August 2025
Design Development Updates

Upper Brook Street Masterplan (McLaren / Kadans)

UBS-SRA-XX-XX-RP-A-00101

This document has been produced by Sheppard Robson and proposes minor changes to the approved Sci-Tech scheme located in Upper Brook Street, Manchester.

Fifth Floor
Consented Plan

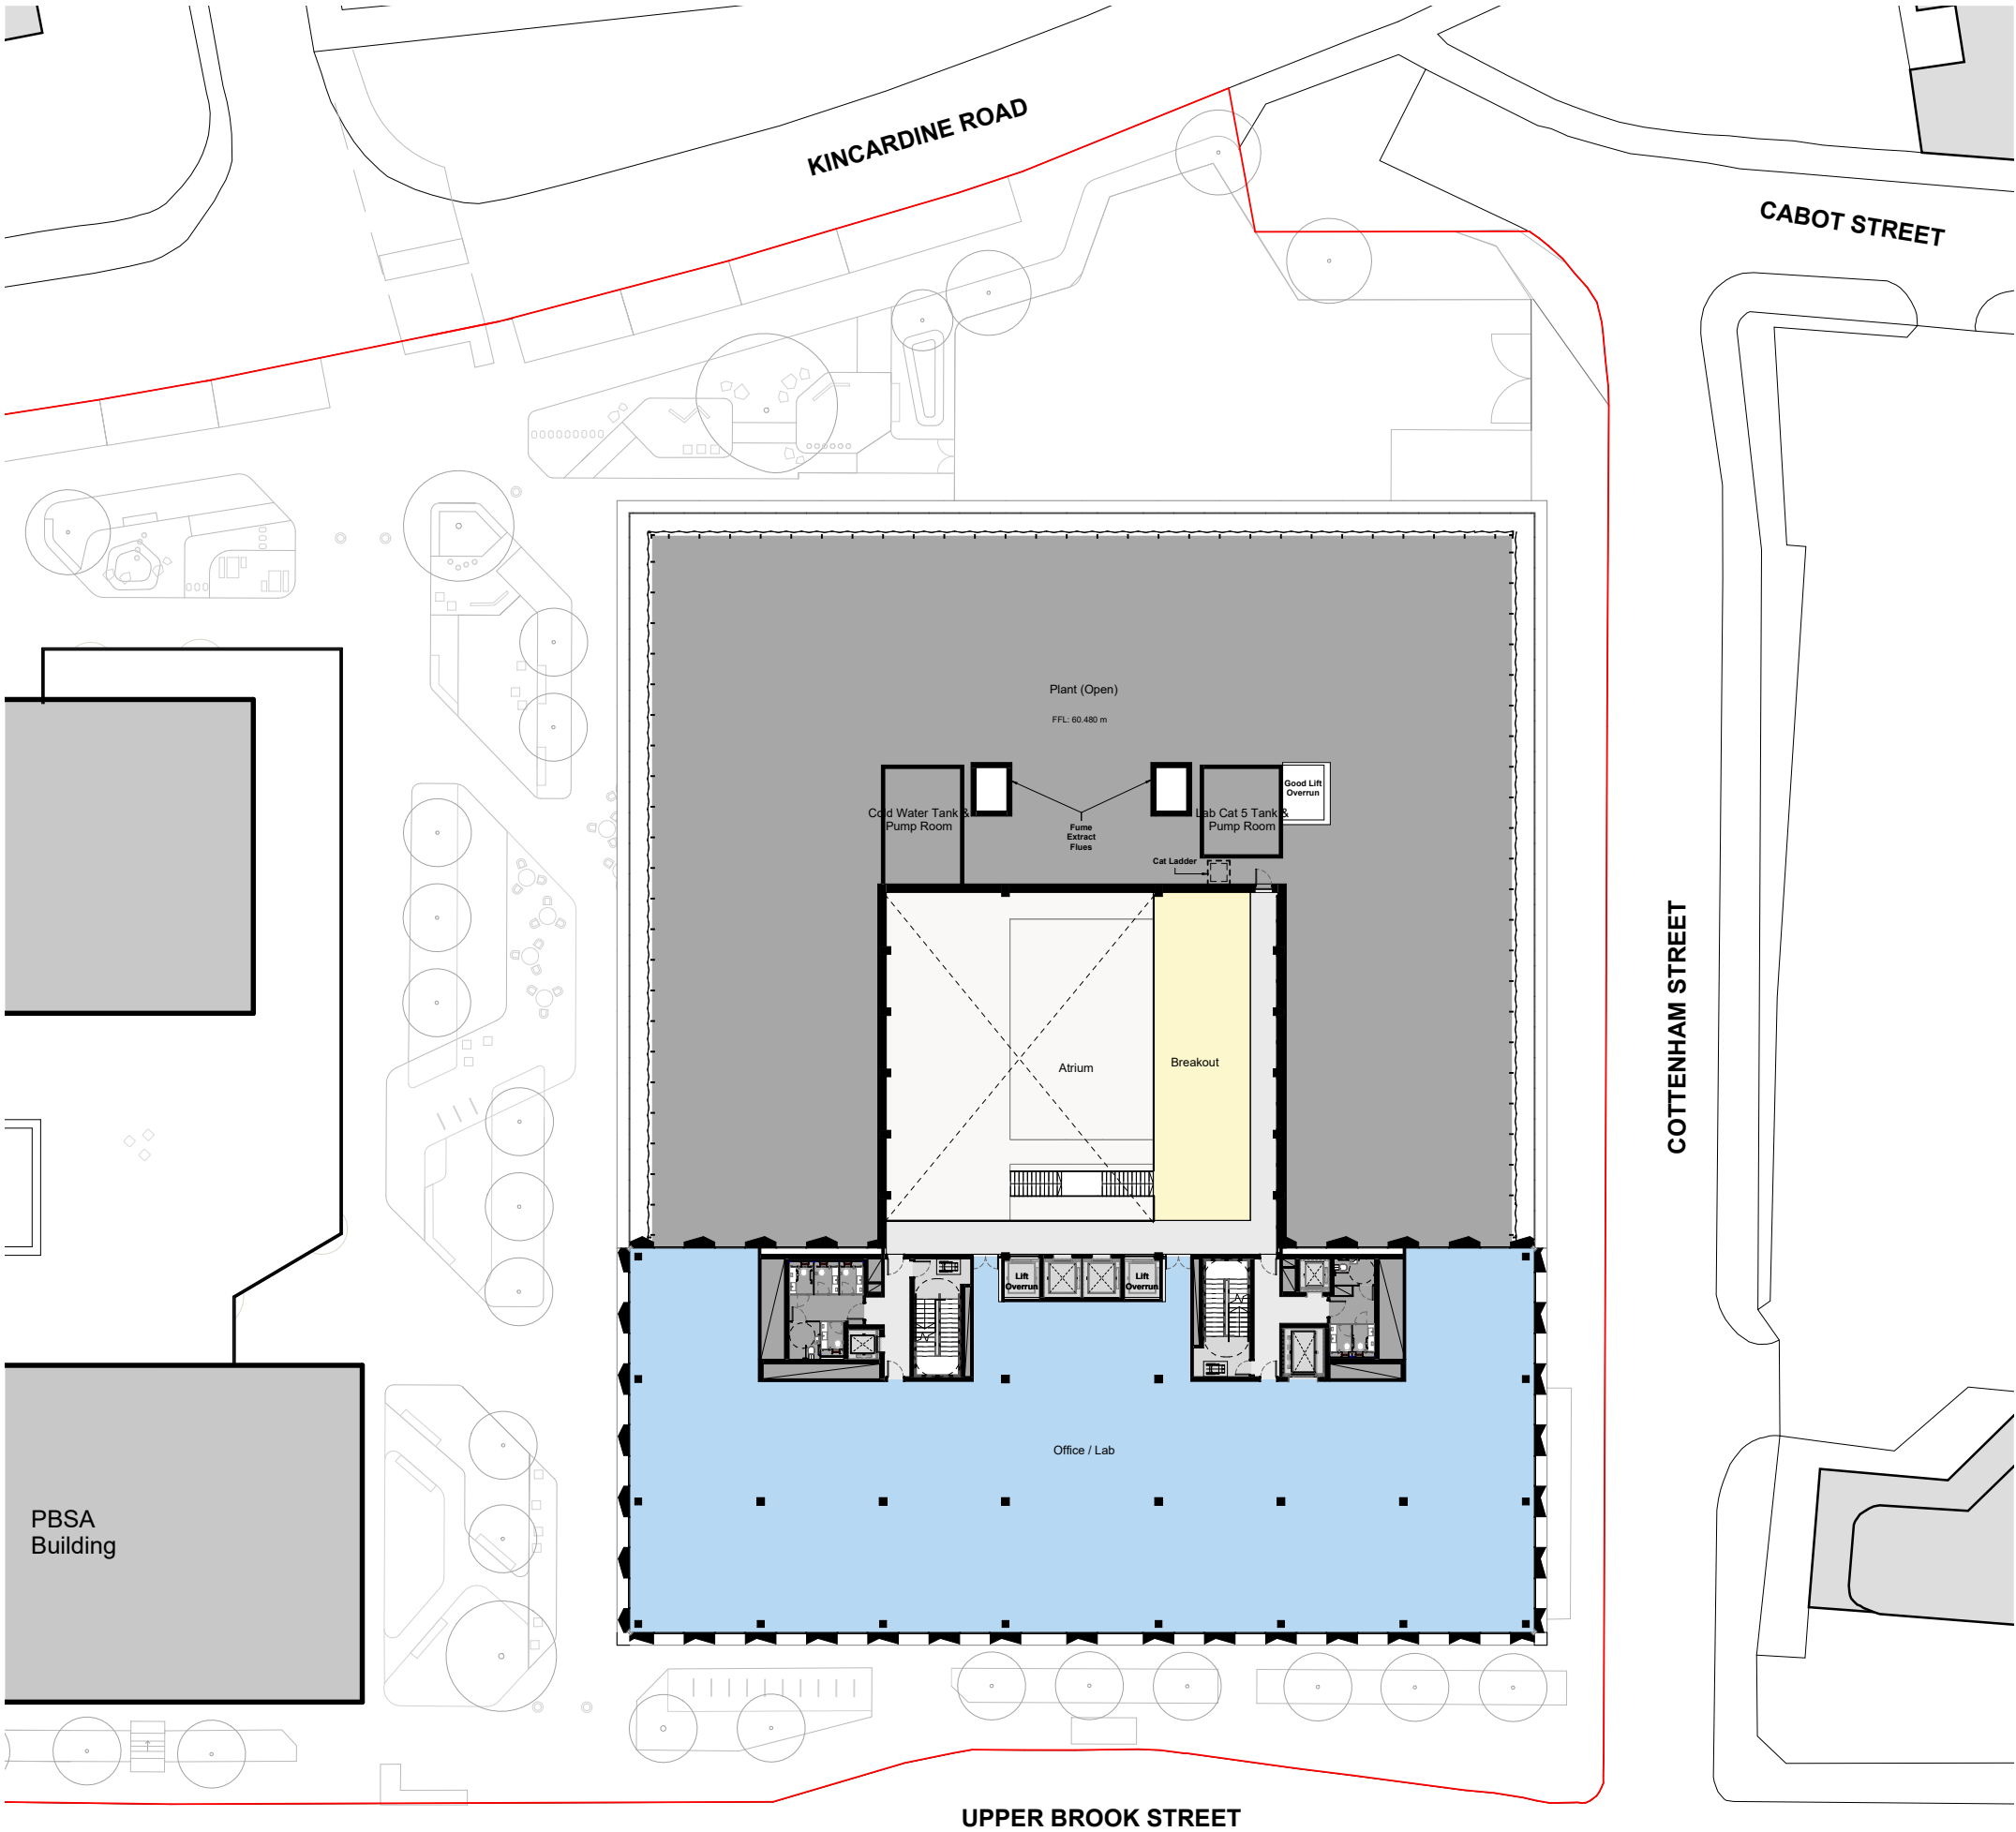
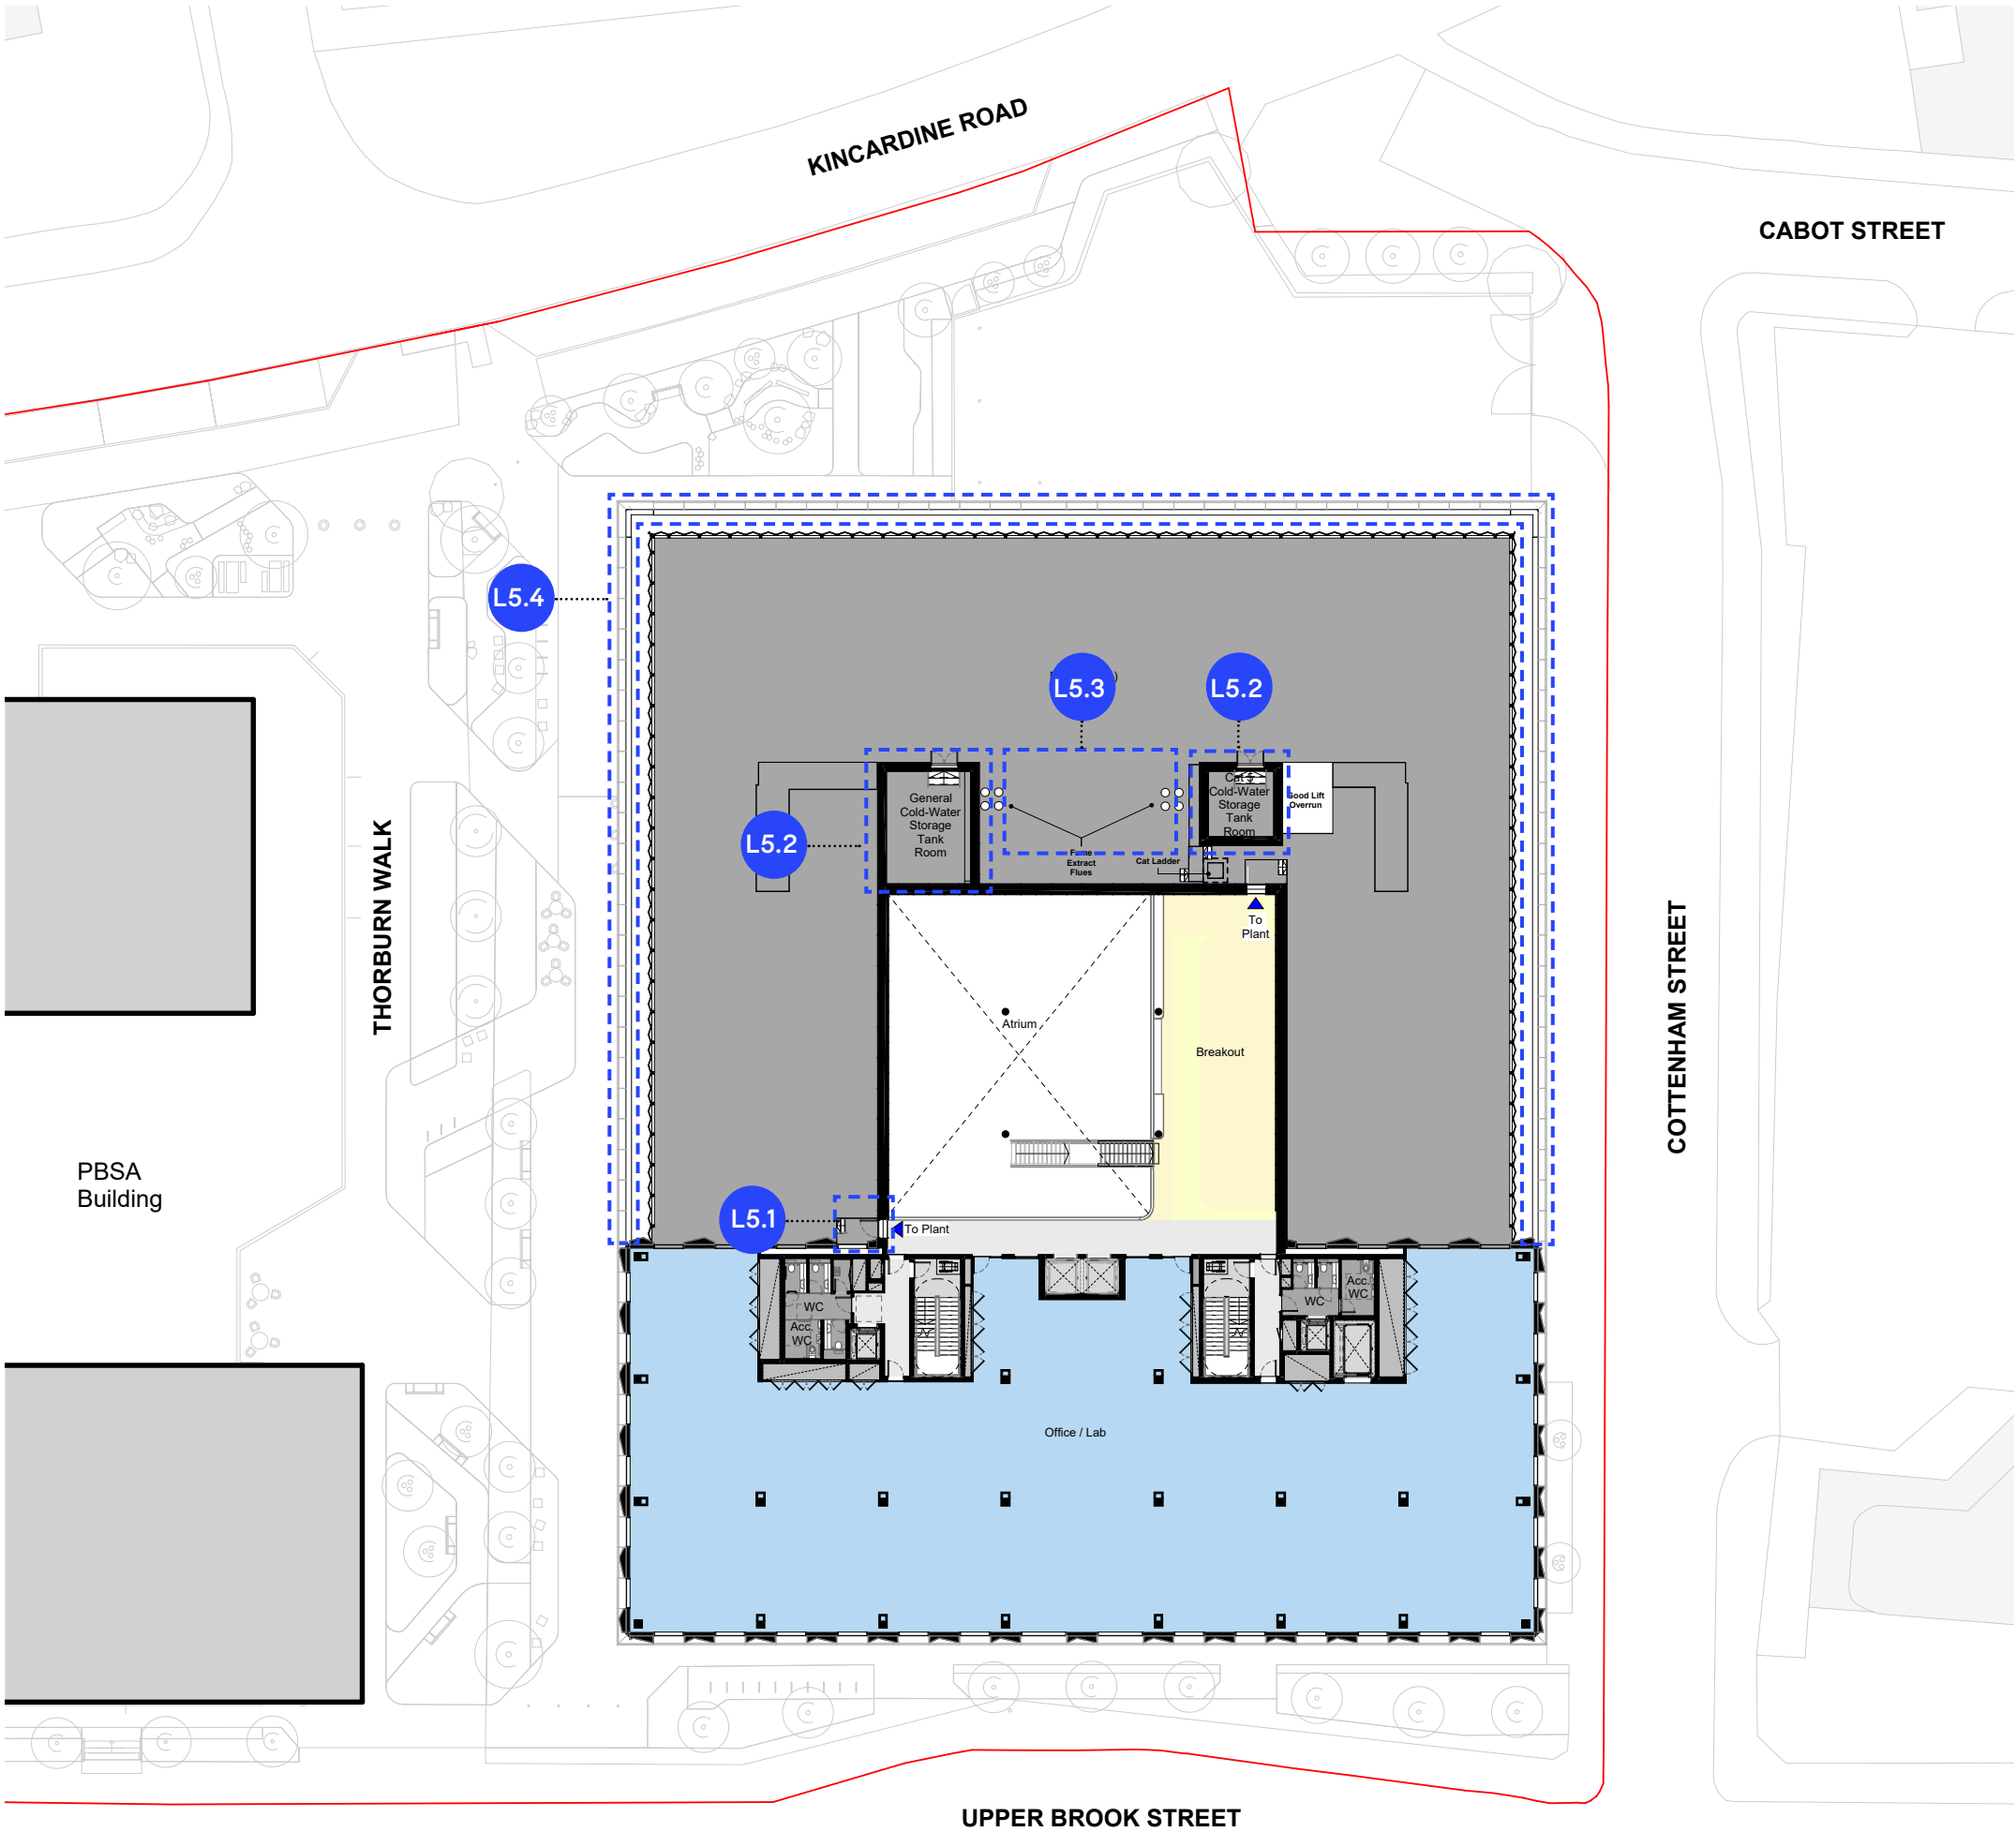
- L5.1** Roof access door was added to provide additional access from the atrium.
- L5.2** The water plant room footprint slightly increased following MEP coordination.
- L5.3** The future tenant flue zone was clarified, and flues have been included for illustrative purposes.
- L5.4** The Level 05 parapet detail was developed.

Change Code	Drawings Affected	Description	Design Development Justification
L5.1	• UBS-SRA-ST-05-DR-A-02-505	• Roof door access added	• Additional roof access through atrium space added following design development and coordination with fire specialist regarding escape distances and roof access and maintenance requirements
L5.2	• UBS-SRA-ST-05-DR-A-02-505 to 509 • UBS-SRA-ZZ-ZZ-DR-A-02-103* • UBS-SRA-ZZ-ZZ-DR-A-02-104* • UBS SRA ZZ SN DR A 02-322	• Water plant room extent increased	• Extent of water plant room modified following MEP design development
L5.3	• UBS-SRA-ST-05-DR-A-02-505 • UBS-SRA-ZZ-ZZ-DR-A-02-103* • UBS-SRA-ZZ-EN-DR-A-02-306 • UBS-SRA-ZZ-EW-DR-A-02-311 • UBS-SRA-ZZ-SN-DR-A-02-322 • UBS-SRA-ZZ-EE-DR-A-02-308	• Future tenant flue zone clarified	• Following building services coordination, flue design and zone has been clarified, flues have been included for illustrative purposes.
L5.4	• UBS-SRA-ST-EN-DR-A-02-400 • UBS-SRA-ST-EE-DR-A-02-401 • UBS-SRA-ST-EW-DR-A-02-403 • UBS-SRA-ZZ-EE-DR A-02-308 • UBS-SRA-ZZ-EN-DR-A-02-306 • UBS-SRA-ZZ-EW-DR-A-02-311 • UBS-SRA-ZZ-SE-DR-A-02-320 • UBS-SRA-ZZ-SN-DR-A-02-322	• Level 05 parapet detail was developed.	• Following facade development, the parapet detail was developed.

Fifth Floor
Arkley Street View

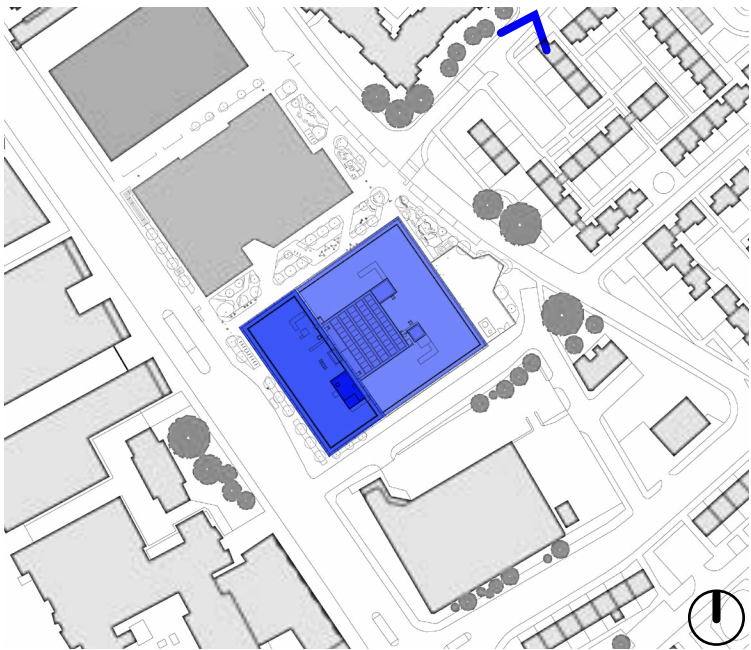
- L5.3 The future tenant flue zone was clarified, and flues have been included for illustrative purposes.
- L5.4 The Level 05 parapet detail was developed.

Fifth Floor
Whitekirk Cl. View

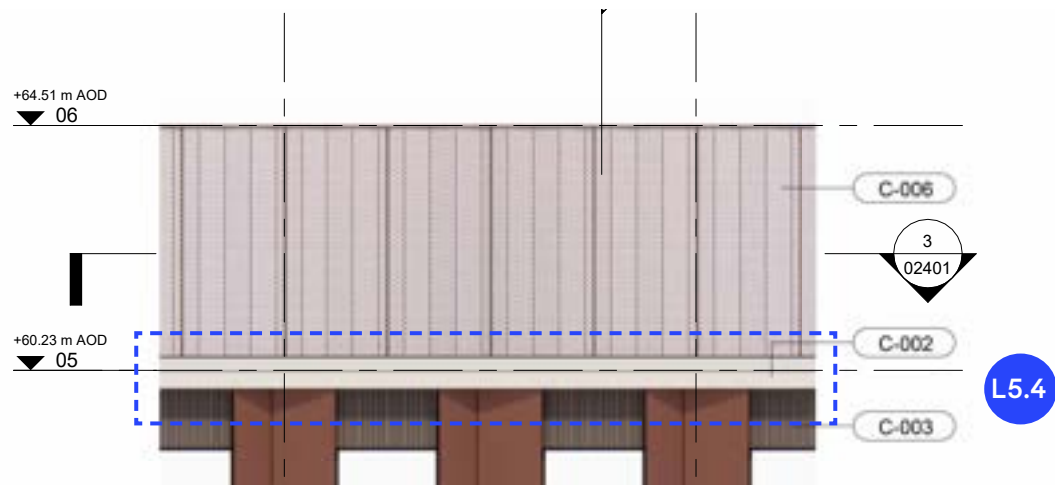
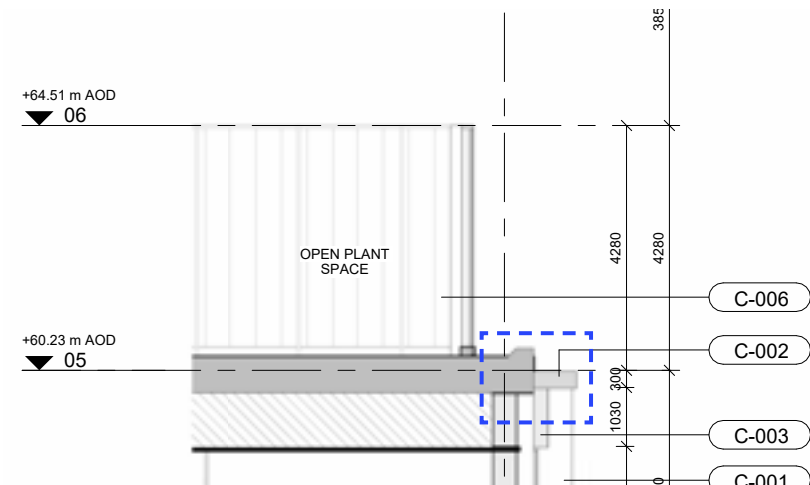
- L5.2 The water plant room extent slightly increased following MEP coordination.
- L5.3 The future tenant flue zone was clarified, and flues have been included for illustrative purposes.
- L5.4 The Level 05 parapet detail was developed.

Parapet height

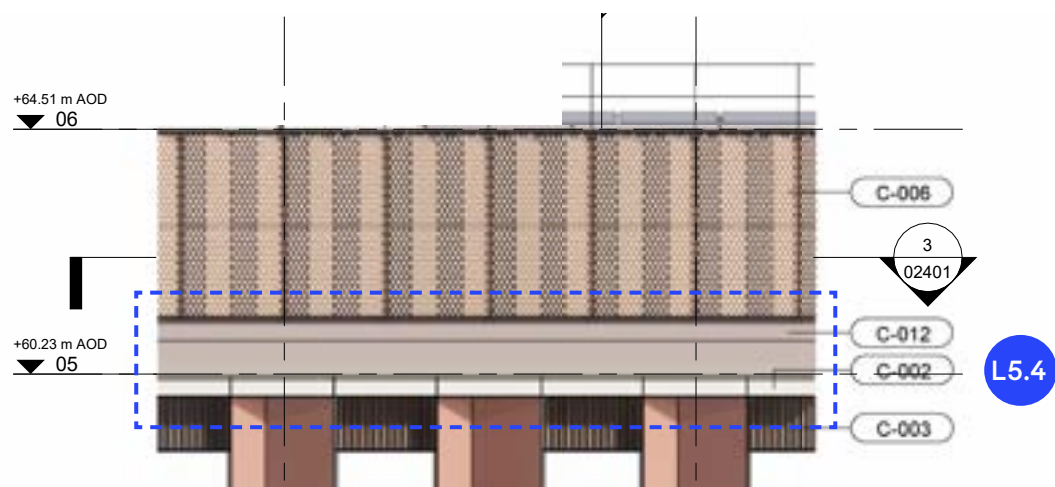
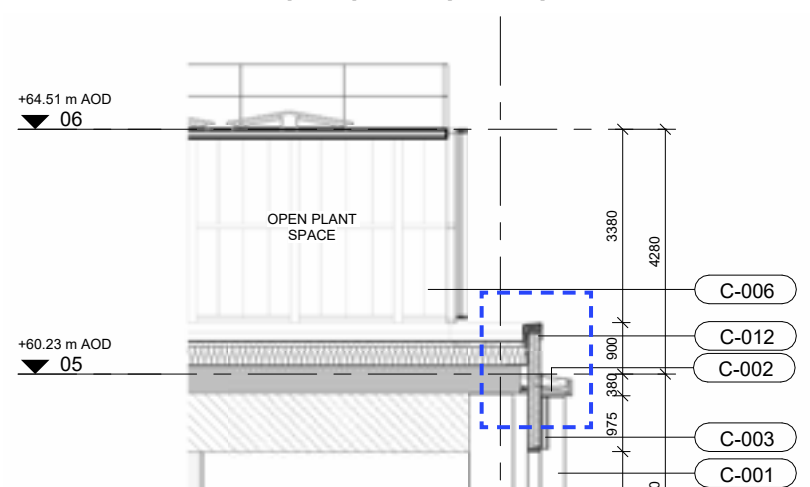
L5.4 Parapet height detail was developed following design development.
